AMENDMENT NO. 1 MARCH 1989

IS : 5444-1978 SPECIFICATION FOR PARALLEL HAND REAMERS WITH PARALLEL SHANKS

(First Revision)

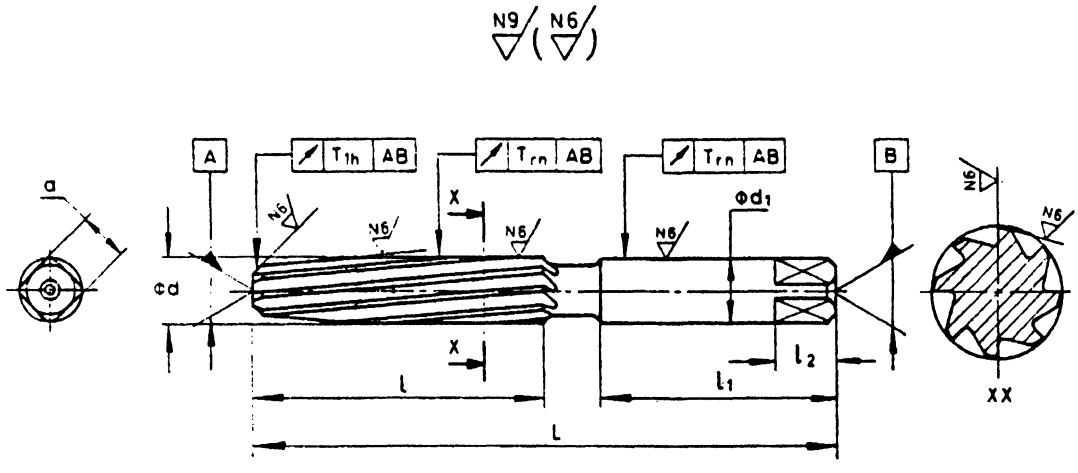
(*Page* 2, *Table* 1, *Figure*) — Substitute the following figure for the existing figure:
